Children's Hospital Westmead, Paediatric Services Building, Design Changes

Further to recent correspondence, please find herein a brief letter detailing the expected impact of the minor geometric change on the local wind conditions in and around the site, and on the balcony compared with those modelled in our Environmental Wind Assessment report dated 17 June 2021.

Figure 2. Classification of wind comfort on terraces based on the previous CFD assessment.

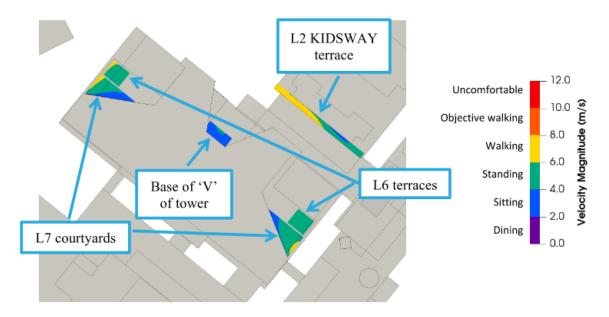
The comparison is also made in relation to balconies. It is understood that the accessible terraces are annotated in the drawings. There are two new accessible terraces on Level 6 shown in Figure 1. The triangular notch created in the revised design would improve wind conditions in the terraces. In the previous design, L6 and L7 terraces were assessed, Figure 2. These wind conditions shown in Figure 2 would be similar or improved for the current design and therefore suitable for standing type activities.
